Cyclic Friction

SUPPLEMENTAL TYPE CERTIFICATE

Installation of Cyclic Stick Control Friction as a Direct Replacement for the Bell Cyclic Knob and Shaft Assembly in accordance with Aero Design Ltd. Document Control List DCL952-1

Title/Description of Design Change: Production Improvements:
Brazing option for Threaded Rod Assy and a new welded Tube
Assembly replacement for a two-piece pressed assembly.

Figure 3.1.2 – Threaded Rod Assembly – 95212

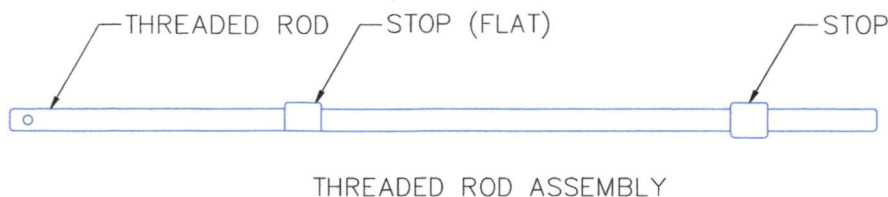
- Add brazing as an alternate process to retain the stops on the fabrication drawing
- Brazed Threaded Rod Assemblies are planned for the next production run.
- See section 3.0 95212 THREADED ROD ASSEMBLY INFORMATION for additional details.

The original configuration of the threaded rod assembly, on issue 1 of the STC, retained the stops by welding in a hole drilled into the stop. The heat required to fill the hole with weld caused the threaded rod to deflect significantly, so each rod had to be manually straightened to ensure correct operation of the friction assembly. The weld on the stop was changed on issue 2 of the STC to a small tack weld on the end of the stop, which does reduce deflection but not entirely so manual straightening is still required.

The updated configuration will be used for the next production run. No outside dissemination of the change is required.

Figure 4.1.1 – Tube Assembly – 95214

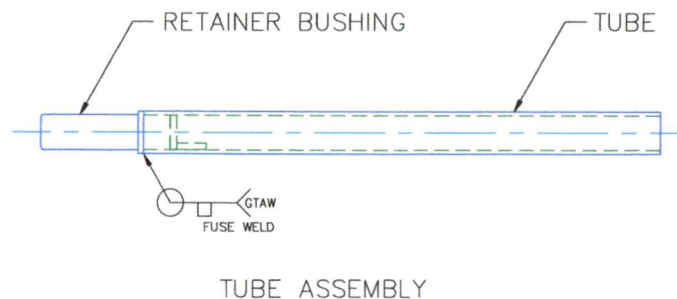
- Create new assembly consisting of Retainer Bushing welded to Tube.
- Existing Friction Assemblies are not affected as each has been checked for sufficient fits on assembly
- Updated welded Tube Assemblies are planned for the next production run.
- See section 4.0 95214 TUBE ASSEMBLY INFORMATION for additional details.

This update creates a new sub-assembly consisting of a 95220-01 Tube and a 95222-01 Retainer Bushing fuse welded together. This is in response to the variability found in the stock material used for the 95220-01 Tube, 3/8" x 0.035 round 304 stainless steel tube, particularly when large batches of mating components are produced by automated (CNC) machining methods. The original assembly of the 95210-01 Friction Assembly relied solely on press-fit of the components, but it has been found the variation in stock diameter of the tube can prevent a press-fit to be achieved when inserting the 95222-01 Retainer Bushing. The outside diameter tends to be oversize, which does not prevent press-fit assembly with the mating caps.

The update does not change the original dimensions of the Retainer Bushing, but instead adds a fuse weld when it is assembled with the Tube to ensure the Retainer Bushing cannot rotate if the fit is not sufficient to do so. The Retainer Bushing must not rotate as it prevents the Threaded Rod Assembly from rotating so the Cam Lever can be adjusted to apply the desired level of friction on the cyclic.

A new part number is assigned to the assembly of the Tube and Retainer Bushing so parts can be identified in-process. A new part number for the Friction Assembly is not required because the new welded assembly is interchangeable with the original press-fit parts.

The updated configuration will be used for the next production run. No outside dissemination of the change is required.

01 CRESCENT BUSHING

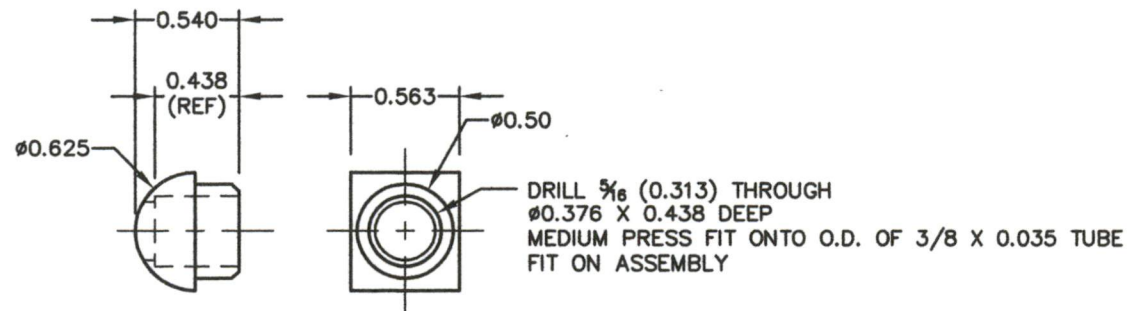
REV.	DESCRIPTION OF CHANGE	INITIALS	DATE
0	INITIAL ISSUE		
1	TITLE BLOCK UPDATED; FINISH NOTE ADDED	BJC	14/10/2013
2	ANODIZING CHANGED FROM TYPE III TO TYPE II	BJC	08/09/2016

1. REMOVE ALL BURRS AND BREAK SHARP EDGES.
2. ANODIZE ALL ALUMINUM PARTS IN ACCORDANCE WITH MIL-A-8625F, TYPE II.

01 CURVED WASHER

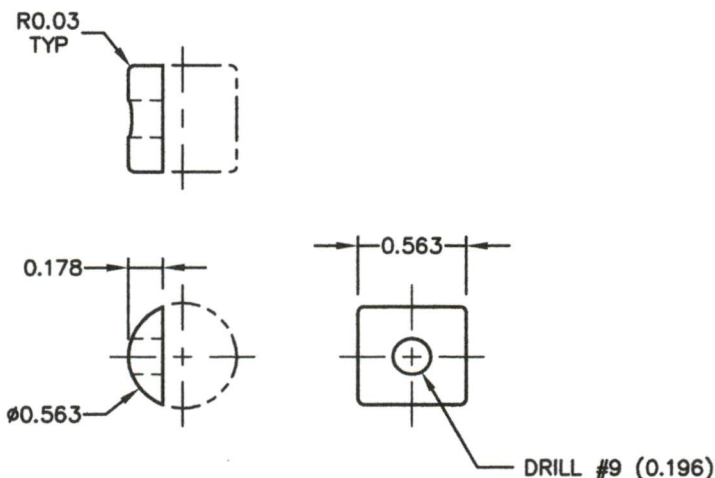
REV.	DESCRIPTION OF CHANGE	INITIALS	DATE
0	INITIAL ISSUE		
1	TITLE BLOCK UPDATED; FINISH NOTE ADDED	BJC	14/10/2013
2	ANODIZING CHANGED FROM TYPE III TO TYPE II	BJC	08/09/2016

1. REMOVE ALL BURRS AND BREAK SHARP EDGES.
2. ANODIZE ALL ALUMINUM PARTS IN ACCORDANCE WITH MIL-A-8625F, TYPE II.

SCALE 1 : 1	DWG. SIZE	DWG. NO.	REV.
SHEET 1 OF 1	A4	95210	2

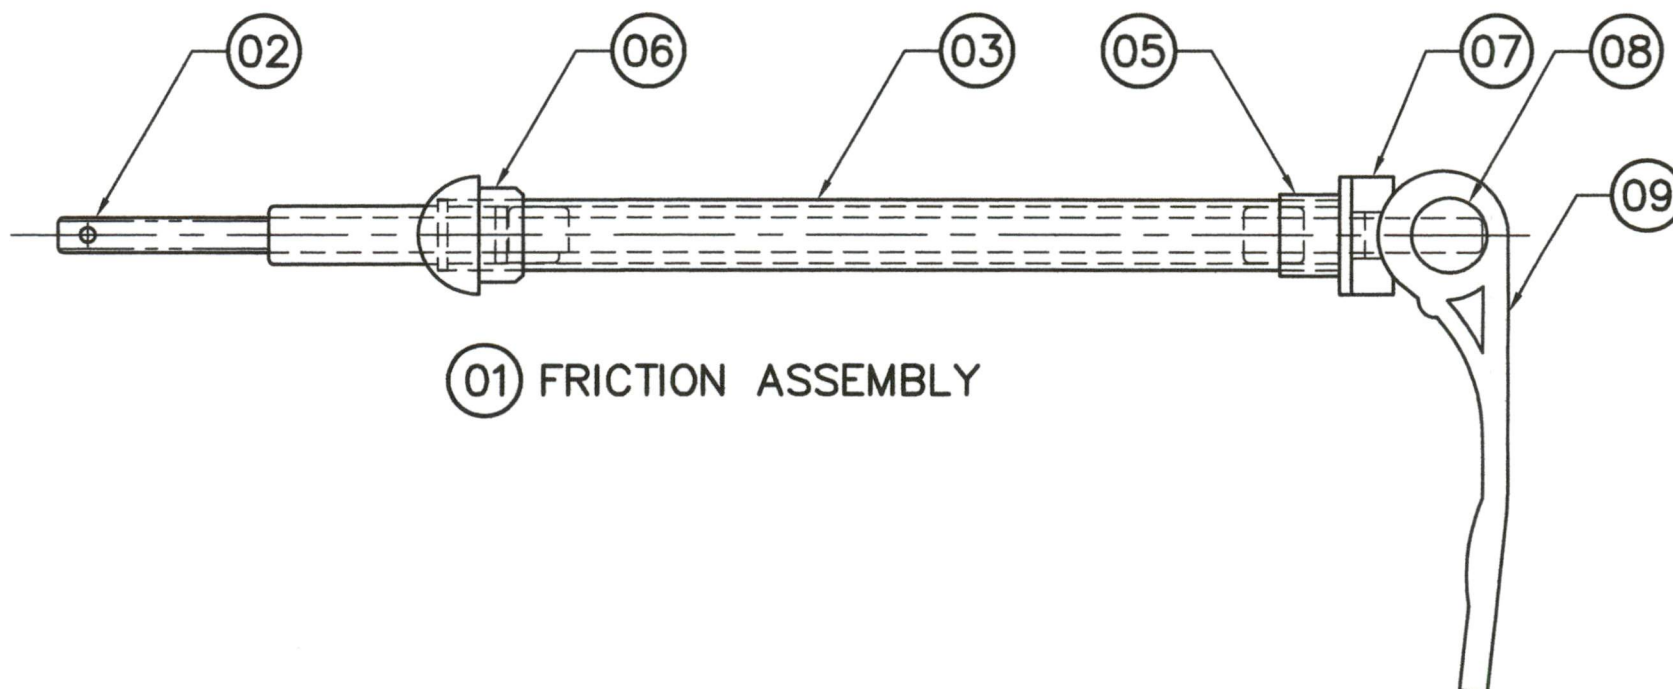
1. 95210 Revision 2: incorporates the new part number for 95214-01 Tube Assembly and updates the assembly instructions accordingly.
2. 95226 Revision 2 and 95238 Revision 2: The anodizing finish is changed from MIL-A-8625F, Type III to Type II. Type III is an engineered hardcoat intended for improved wear resistance on sliding surfaces, which is not required in this application. Type II is the correct coating for this application as a corrosion preventative coating.

01 THREADED ROD ASSEMBLY

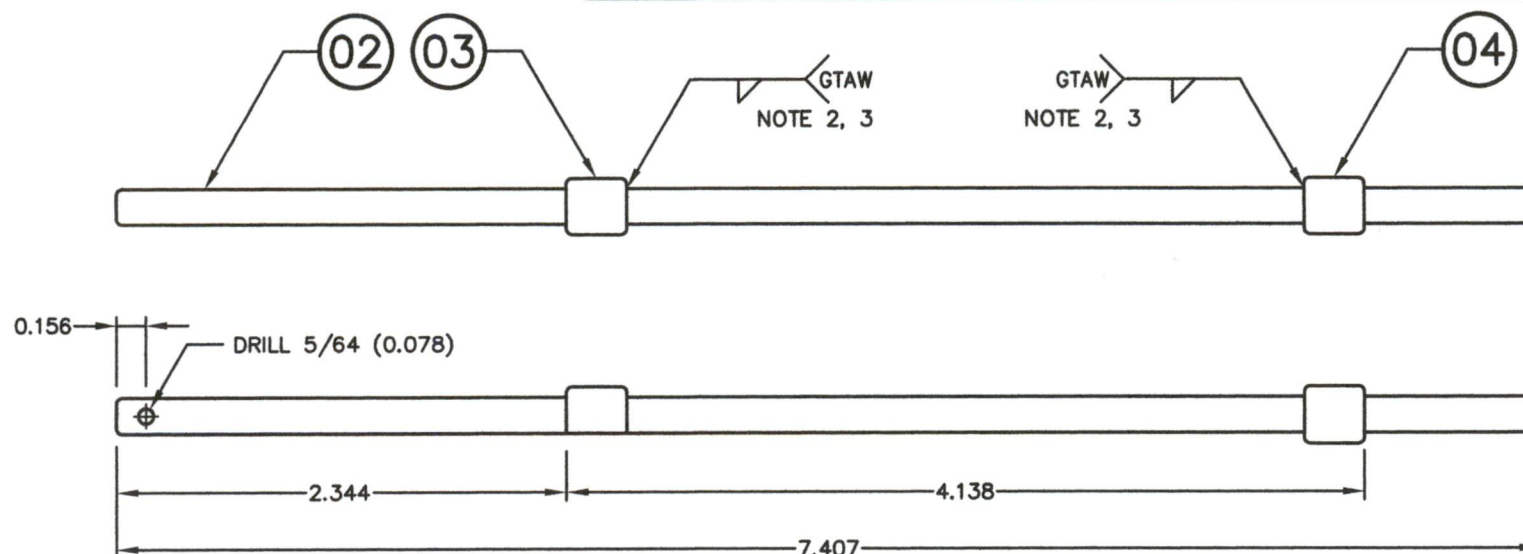
REV.	DESCRIPTION OF CHANGE	INITIALS	DATE
0	INITIAL ISSUE		
1	TITLE BLOCK UPDATED; STOP SPACING CHANGED; WELD CHANGED	BJC	14/10/2013
2	ALTERNATE BRAZING ADDED	BJC	03/08/2016

1. REMOVE ALL BURRS AND BREAK SHARP EDGES.
2. WELDING OF 304 STAINLESS STEEL TO BE COMPLETED BY GTAW METHOD TO AMS2685C. WELDING ROD SHALL CONFORM TO ER308L OR EQUIVALENT.
3. ALTERNATE: JOINTS MAY BE SILVER BRAZED IN ACCORDANCE WITH AC43.13-1B, SECTION 4-77 (2) USING AWS A5.8 BA_g-24 SILVER BRAZING ALLOY OR EQUIVALENT, AND AWS A5.31 FB3C FLUX OR EQUIVALENT. APPLY FLUX TO PARTS AND BRAZING ALLOY.

01 CAP

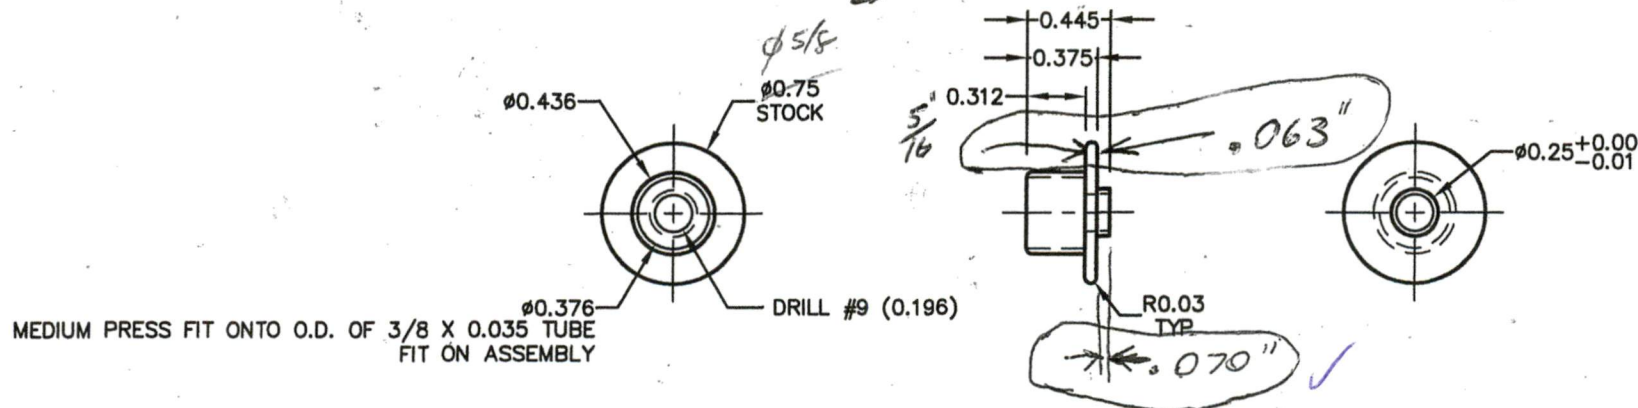
change this dim. ✓
